PUBLIC HEARING/WORKING SESSION MEMORANDUM

PETITIONS #26-20 & #27-20 355 and 399 Grove Street

355 AND 399 GROVE STREET "RIVERSIDE"

RIVERSIDE STATION DEVELOPMENT DESIGN GUIDELINES

Figure I: Wayfinding Signage

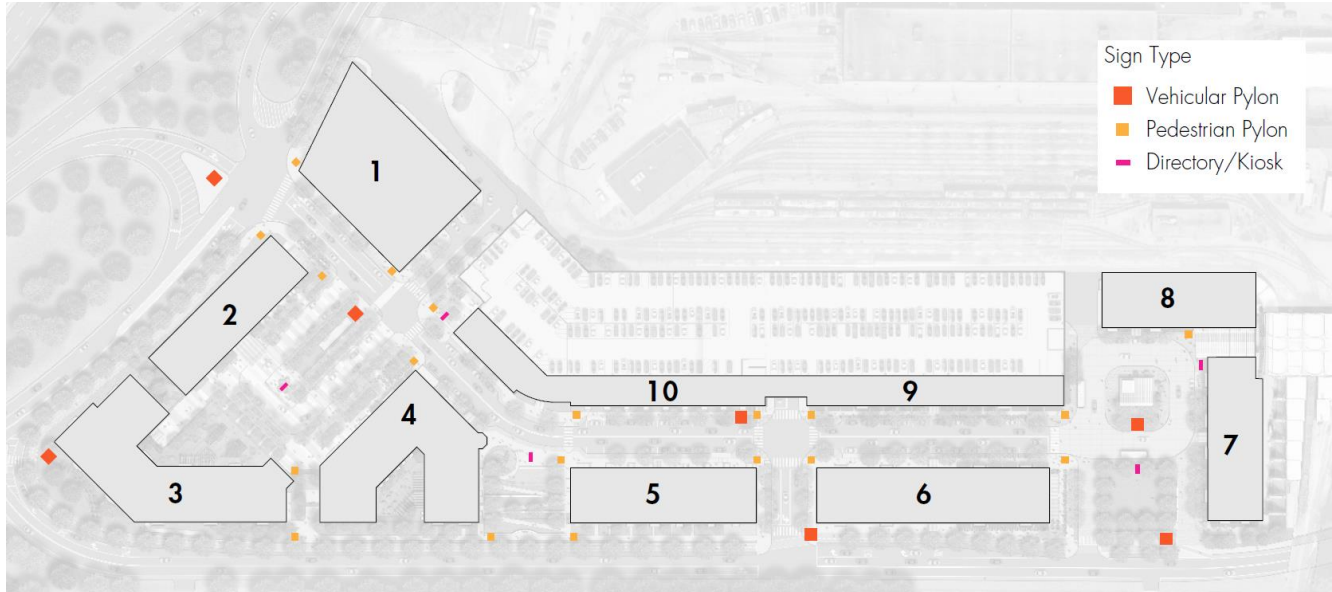
The Planning Department recognizes the importance of signage in attracting and in directing people into the site, but suggests that the petitioners consider reducing the number of vehicular pylon signs along the Grove Street frontage, especially since the signs at Road B and Grove Street and Road C at the Transit Square are within a few hundred feet of each other.

The petitioners are proposing 19 pedestrian pylon signs which may be up to ten feet in height and may contain up to 60 square feet of sign area. These signs would be located at any sidewalk corner to direct pedestrians to any destinations within the Project. Staff understands that these locations are only preliminary but akin the vehicular pylon signs there appear to be three pedestrian pylon signs in proximity along the Grove Street frontage.

The petitioners are proposing directory signs/directory kiosks which may be installed in pedestrian gathering places throughout the site. The petitioners are not sure of the exact number but have shown five such signs total at the following locations: at the hotel green, at the open space adjacent to Building 10, at the amphitheater, at the transit green and at the base of the stairs leading to the transit station platform. The Planning Department does not have concerns with the number or the location of these signs but suggests that the petitioners provide more information as to the dimensions of these signs.

The petitioners are proposing pole-mounted signs which may be mounted ten feet above grade to direct visitors to destinations such as parking, or the transit station. The number or the location of these signs is not known at this time. The Ordinance allows such signs as of right provided they are no greater than three square feet and they do not contain the name of a business. If the signs do contain the name of a business, they are limited to one square foot. Staff suggests the petitioners provide some details as to the maximum number and dimensions of these signs.

Figure II: Building 1 Tenant Signage

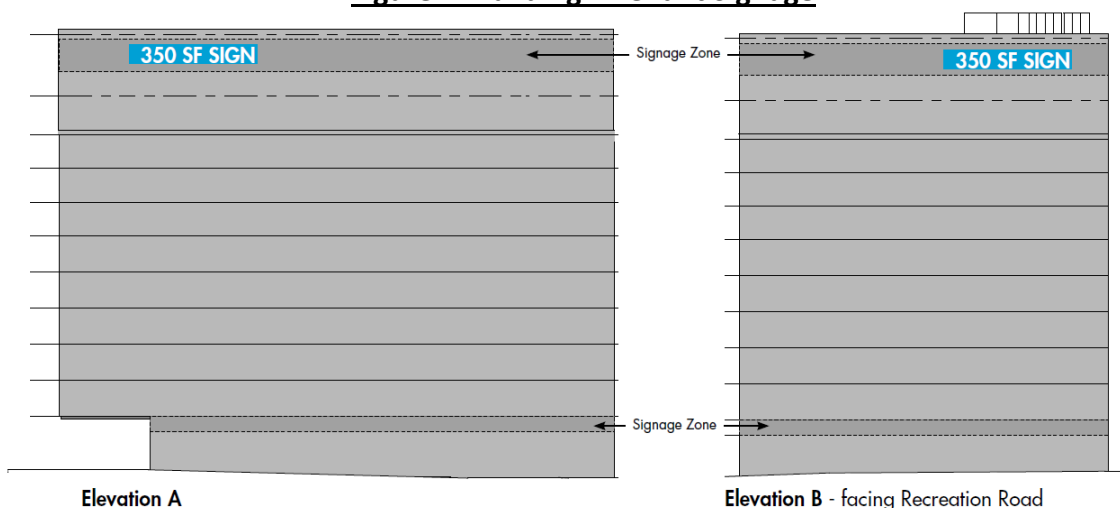
The UDC recognized the desire of these signs for Building 1 but had concerns with the size and with allowing signs on the three facades facing Interstate 95. The UDC felt that too large and/or too many signs would act as billboards and would detract from the design of the building. The UDC suggested that the petitioners be allowed signs on the eastern and western facades (visible from Interstate 95 northbound and southbound) of up to 200 square feet with the opportunity to increase the size of each sign to 300 square feet dependent upon the final design of the building. The UDC also suggested that the petitioners be allowed the flexibility to install a third sign on the southern façade (Elevation B in the above graphic) dependent upon the final design of the building. However, such request may be denied by the UDC.

Figure III: Building 2 Tenant Signage

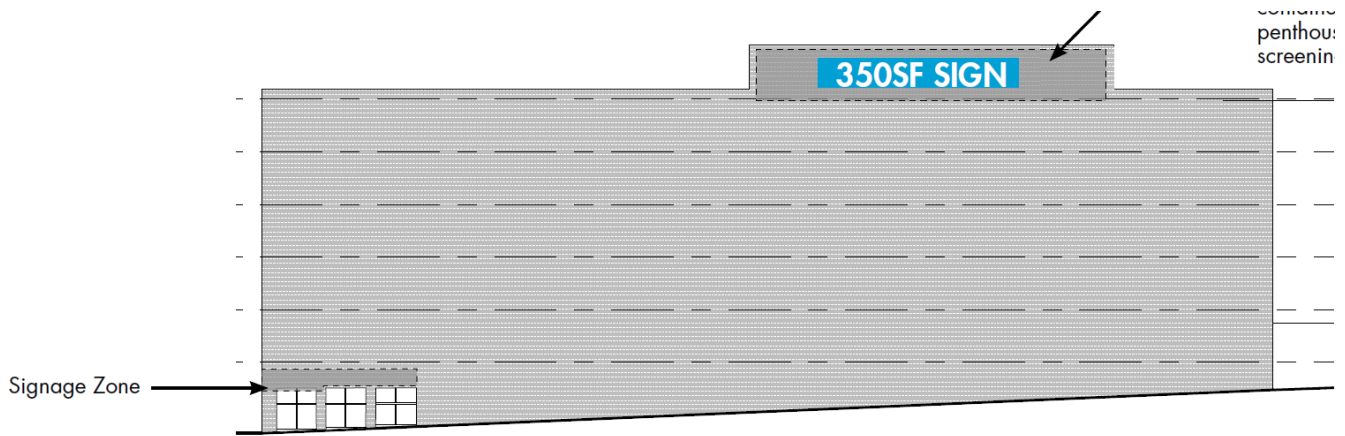
With respect to Building 2, the UDC suggested that the petitioners be allowed one 200 square foot internally illuminated sign, with the possibility of increasing the sign to 300 square feet on the southern facade. Given that the hotel does not close, the sign would be allowed to be lighted all night. The UDC suggested that the lumens of the sign be decreased after 11 a.m. The UDC also suggested that a second size may be allowed on the northern side of Building 2 (fronting the hotel square) dependent upon the final design of the building.
